**TOWN OF HERNDON, VIRGINIA
HISTORIC DISTRICT REVIEW BOARD WORK SESSION AGENDA
HERNDON MUNICIPAL CENTER
LARGE CONFERENCE ROOM, 2nd Floor
777 LYNN STREET
SEPTEMBER 7, 2022
7:00 P.M.**

Title: HDRB #22-011; Front porch alterations; 830 Elden Street

Title: HDRB #22-012; Addition; 702 Elden Street, Suite B

2 PROPOSED FIRST LEVEL
3/16" = 1'-0"

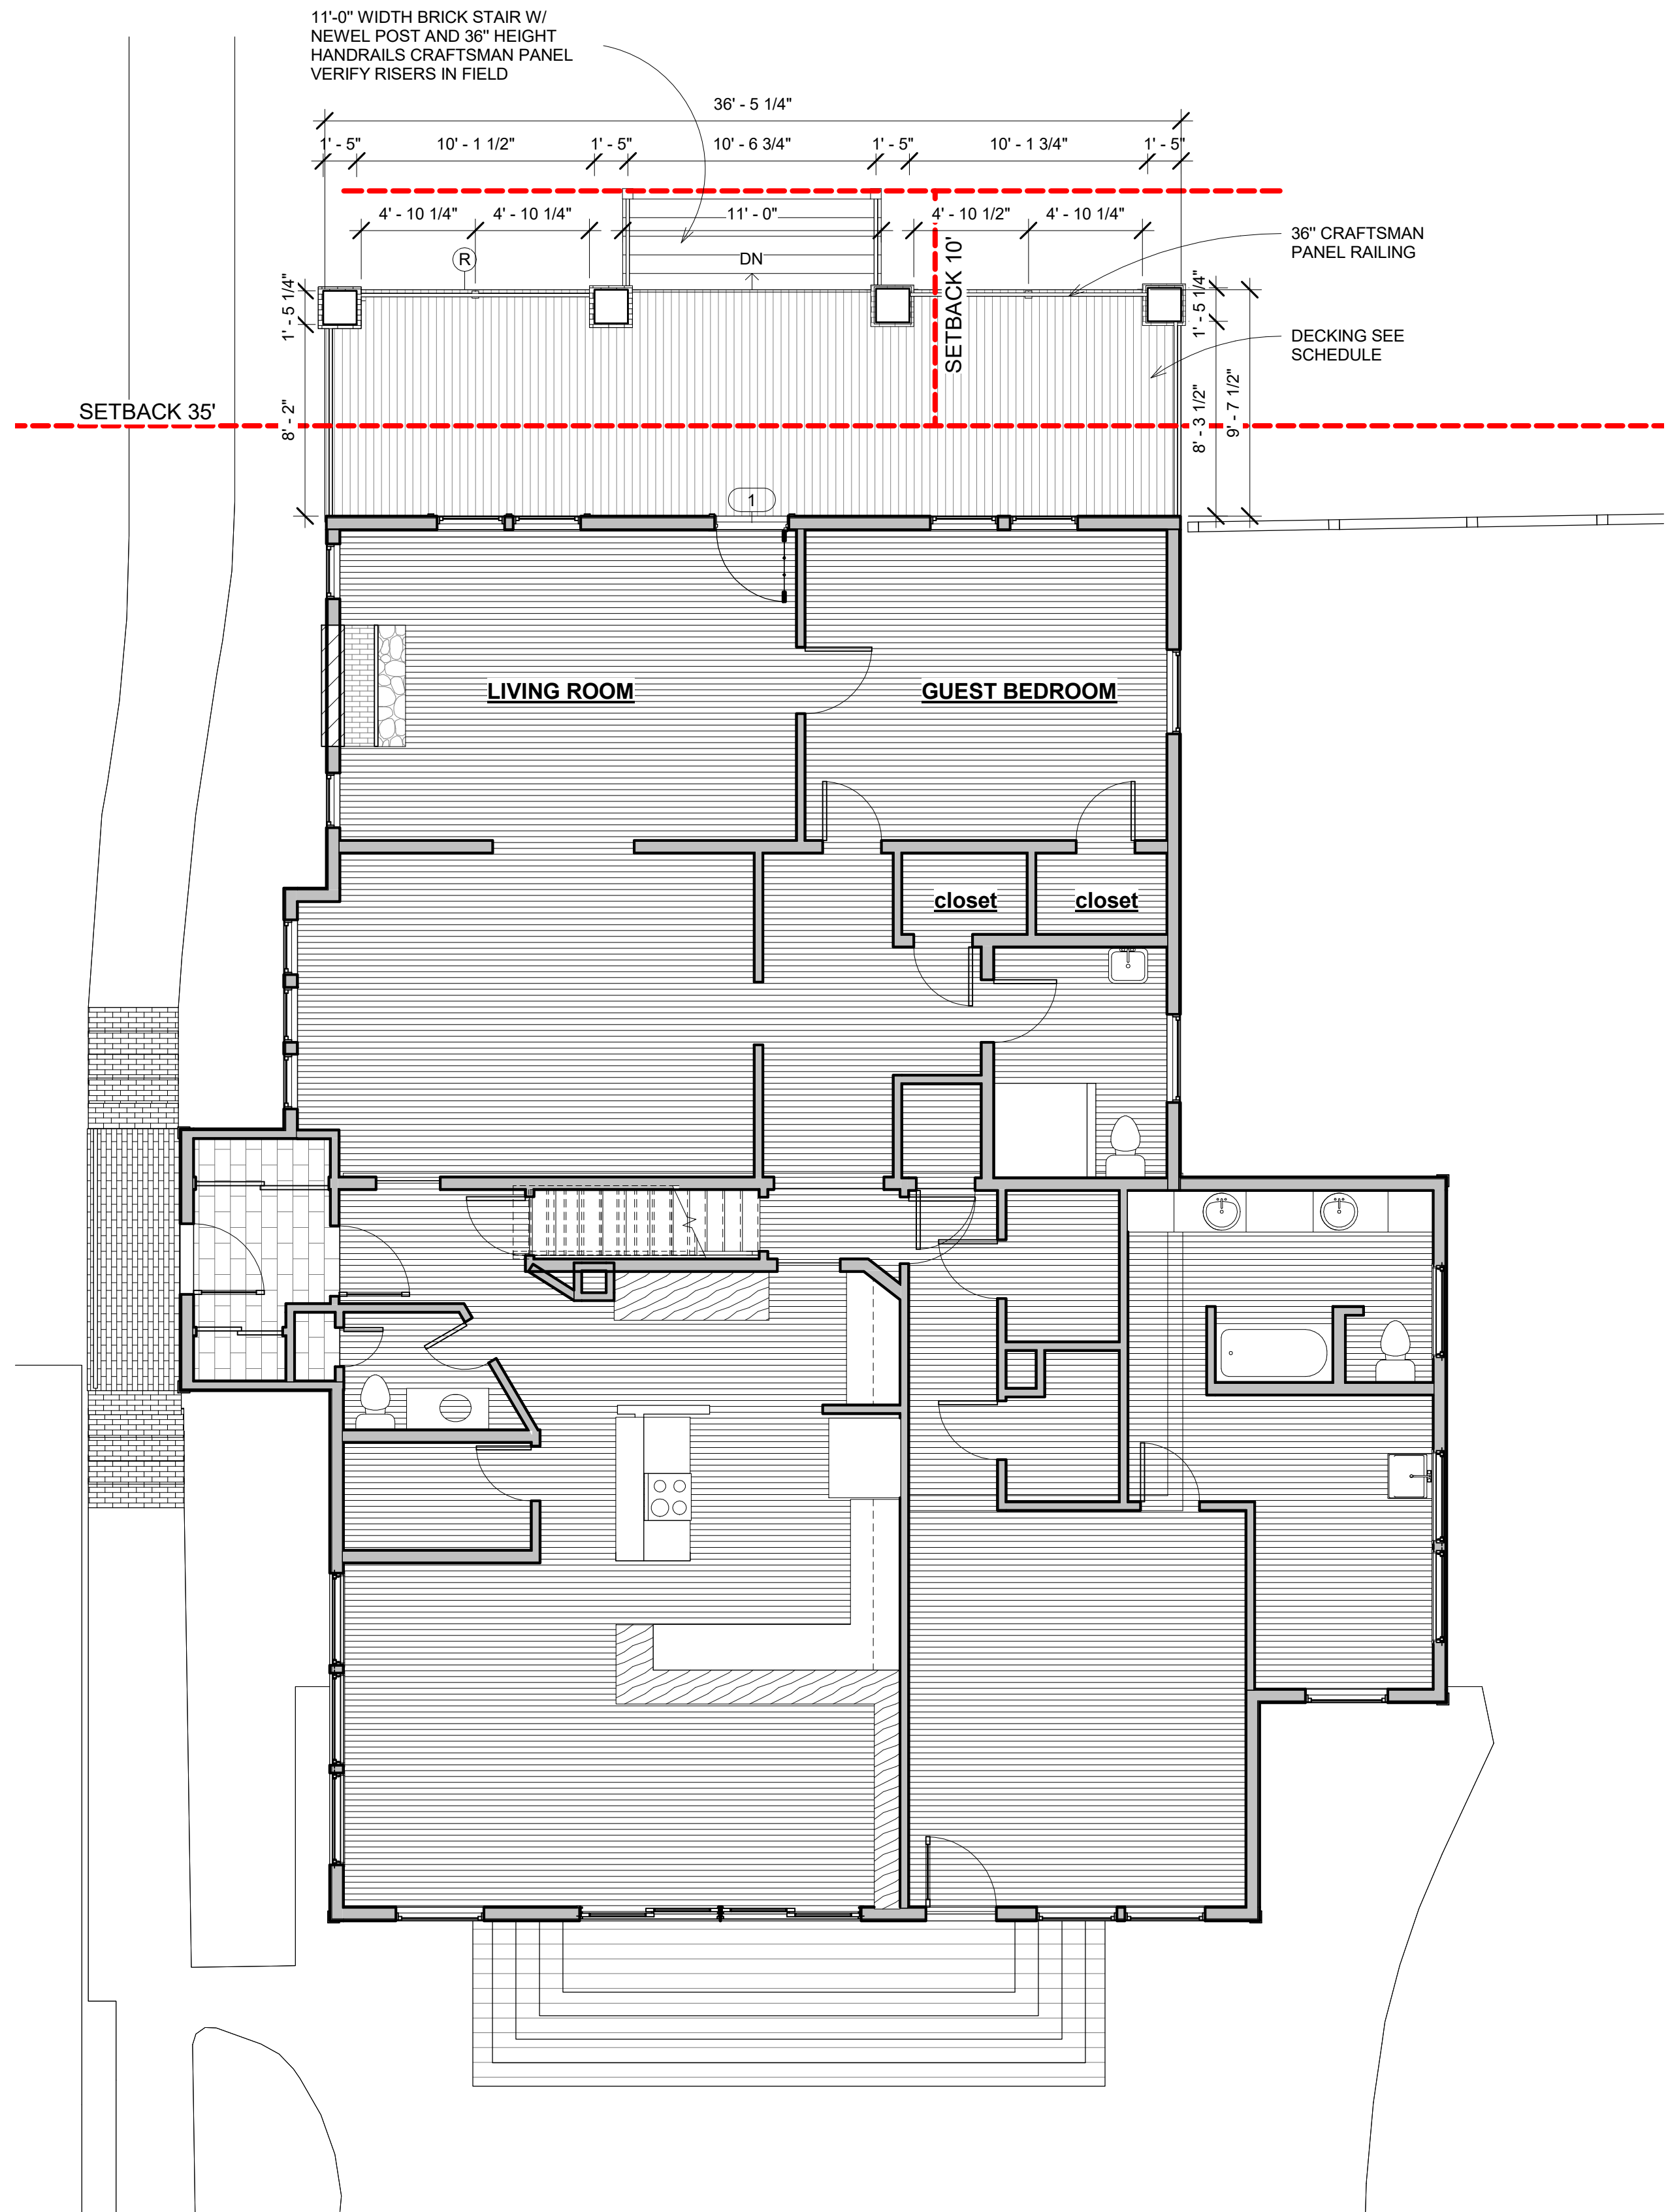
Porch flooring. The proposed porch flooring is Aeratis Traditions Deck Flooring. This product is a tongue and groove assembly and is paintable. This product has been approved previously by the Board for porch flooring replacement projects. The Guidelines state that alternative materials should be able to mimic the look, design, aesthetic and be placed in the same location as the elements they are replacing. The specifications for this product would meet those physical requirements. The application does not specify the layout of the existing or proposed porch flooring. Staff has asked for clarification.

② PROPOSED FRONT ELEVATION
1/4" = 1'-0"

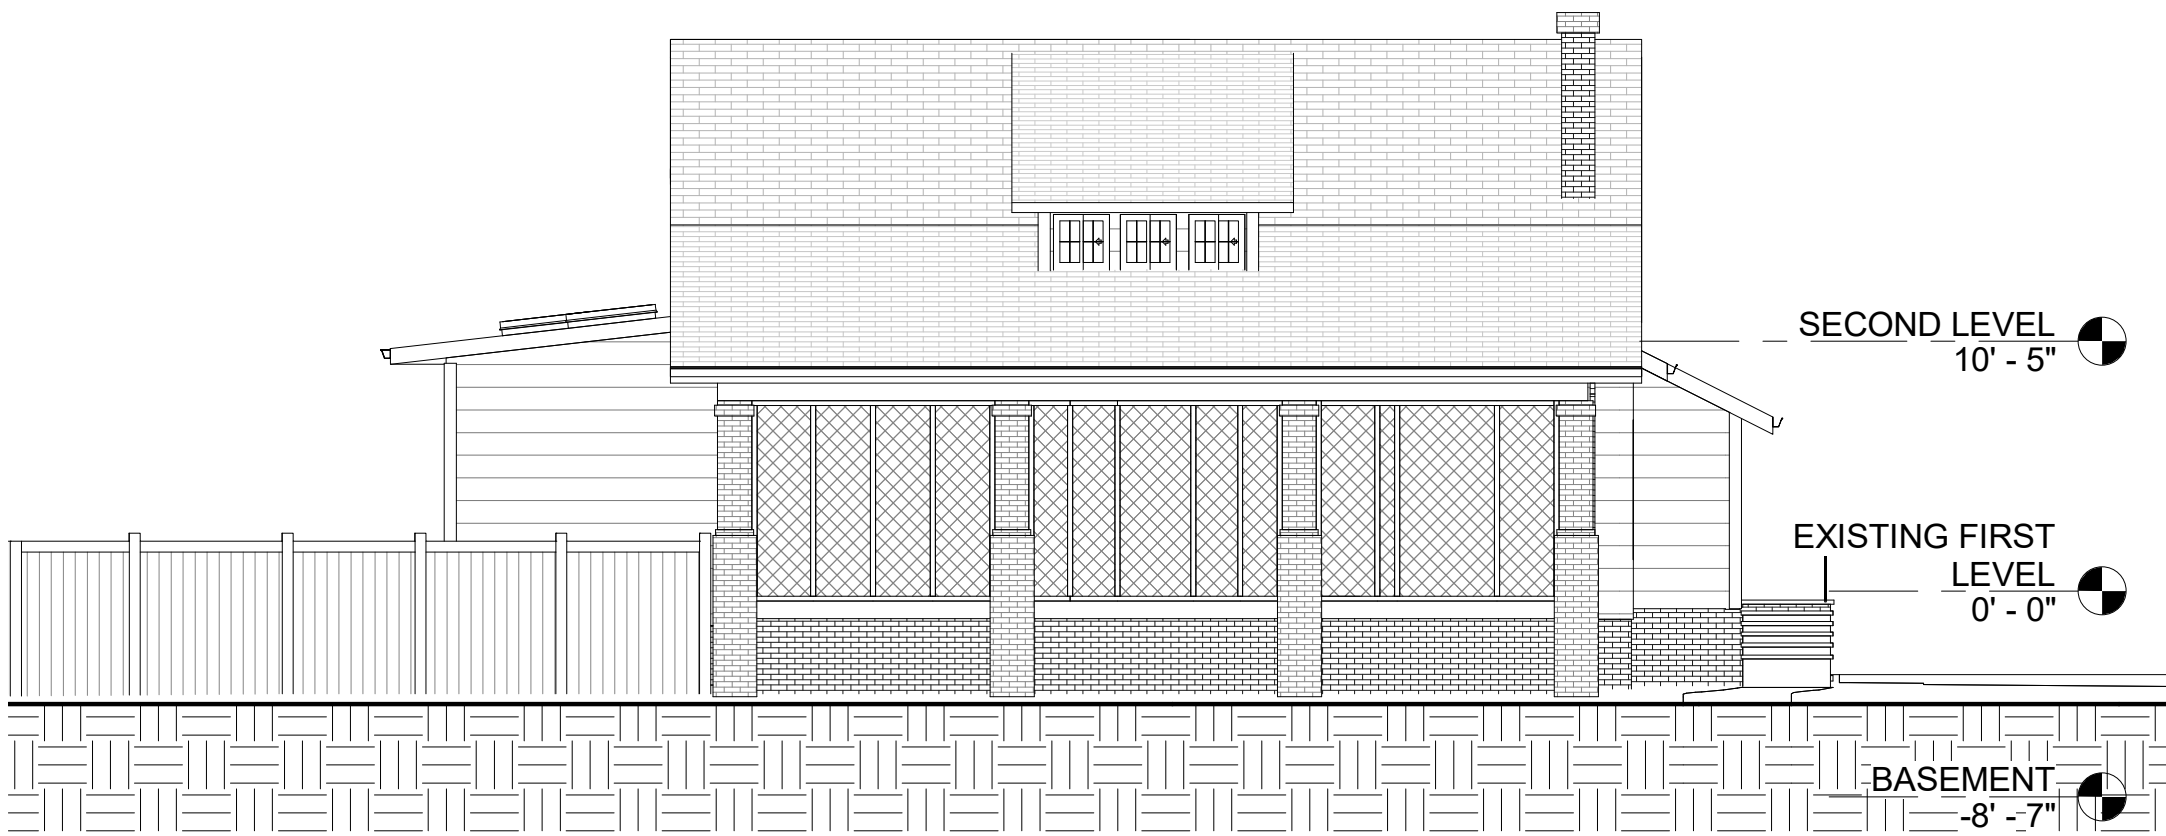
Porch railings. With the removal of screen walls, railings are required by code. In addition to this, railings would most likely have been present originally on this porch. The 1977 photo shows a lightweight twisted baluster metal railing system that is not typical of a 1920s bungalow style house. The proposed railing is 36” craftsman panel railing. However, the specifications provided do not give details regarding material, color, or means of fastening to the porch pillars which are contributing elements. Staff is asking for clarification regarding this proposed product.

Replacement windows and doors. The application does not provide information regarding the details of the existing windows and door that are proposed to be replaced. It is important to understand if elements like these are original or if they have been replaced recently. It appears from the images provided that the dormer windows in existence are not original. However, images of the existing windows would be helpful to fully understand this part of the project. Staff has asked for clarification and images. The proposed replacement windows have fiberglass clad exteriors which has been determined to be an appropriate alternative material for wood windows in the past.

Front porch steps. The proposed front porch steps are in the same location as those in the 1977 photo. Their addition would be appropriate when returning this façade to reflect its traditional appearance and function. The submitted drawings specify that steps will be brick masonry. The board may wish to discuss with the applicant whether and how the brick masonry of the proposed stairs will be visually aligned with the other masonry present on the building in terms of brick color and size and mortar color and width.

Image: 830 Elden Street c 1977

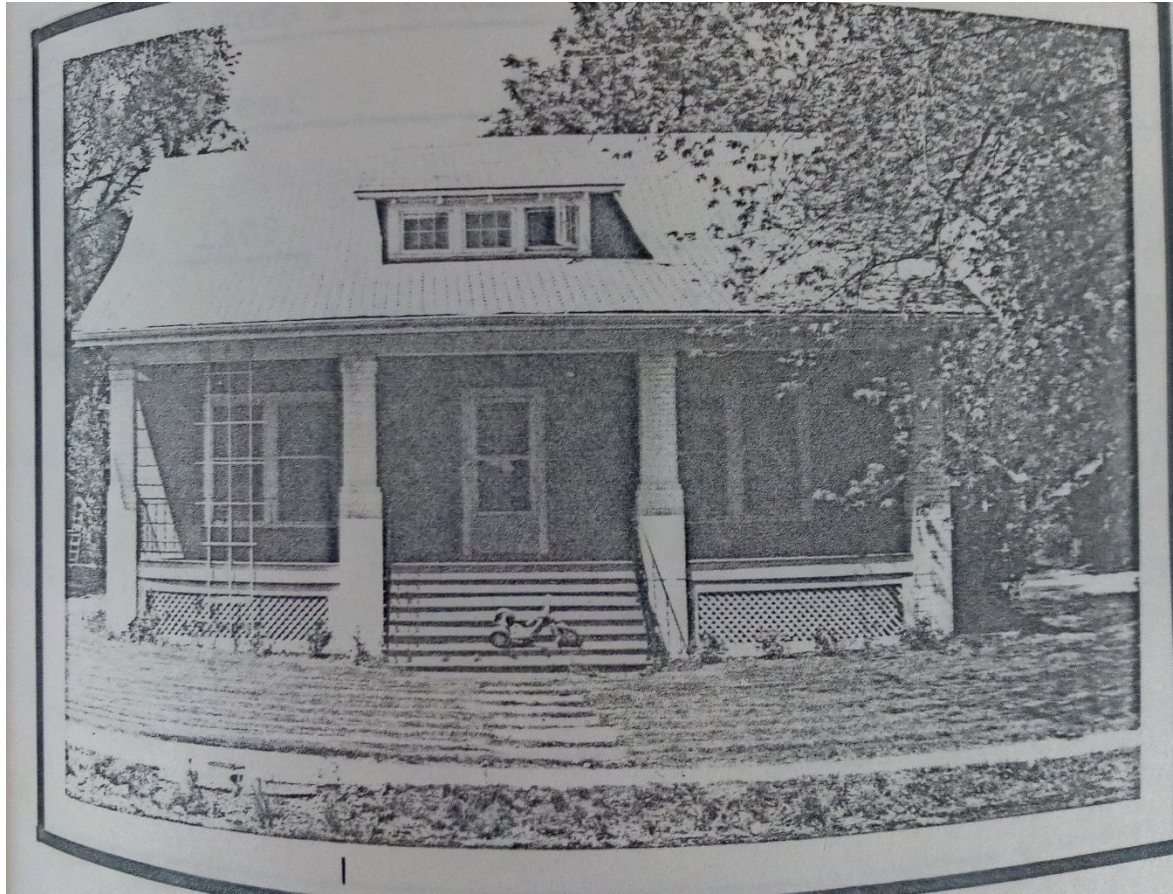
We have access to an earlier photo from 1977 which shows the porch open with stairs leading to the front main entrance. Though not high quality and not from the period of significance, the 1977 photo does give valuable information regarding the general form of the front façade prior to later alterations. The brick porch pillars appear to be the same as present today, while the porch skirting treatment, railing, and dormer windows appear to be different. From this photo and information about typical choices for this style of home during the 1920s, we can understand the general design and form.

Lattice porch skirt. The proposed lattice porch skirt treatment reflects the style of the porch skirt in the earliest photo we have but does not mimic completely. This is in accordance with the Guidelines which discourage design choices that may present a false sense of history. Since the original porch skirting does not exist, re-introducing it in a way that is different from the original is appropriate. The applicant may wish to consider introducing a thicker boarder around the latticework as is visible in the 1977 photo.
